**Subject : Re: Audit 2**  
**FCC ID. : O25PF-400NW**

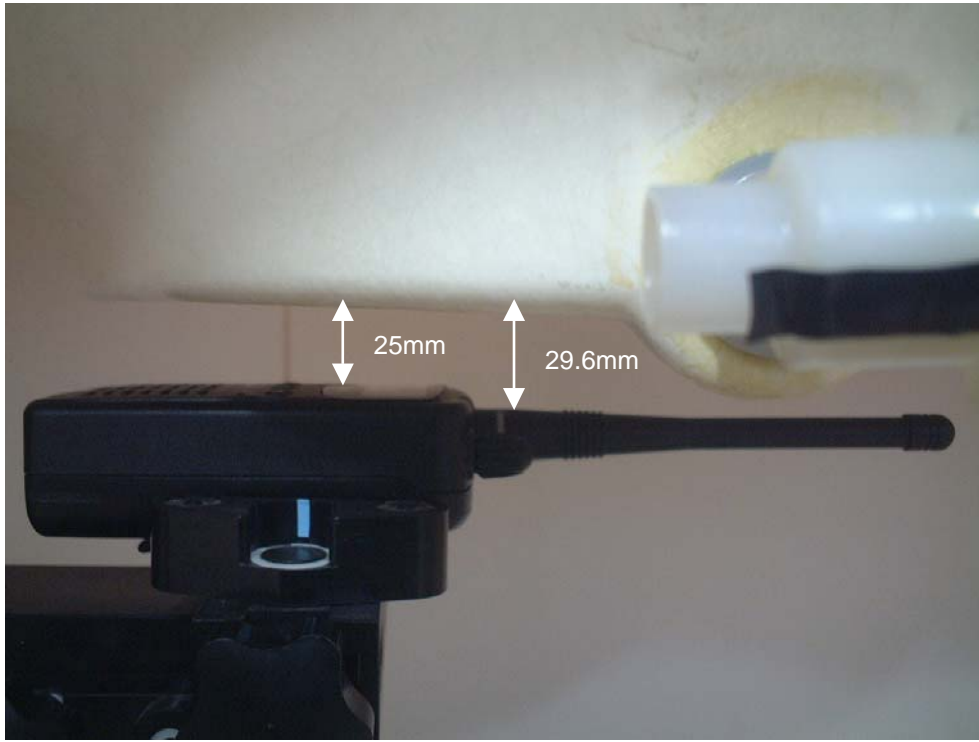
1) What is spacing between back of device and phantom for body-worn SAR, i.e., belt-clip thickness?

Ans) Refer to picture of the next page.
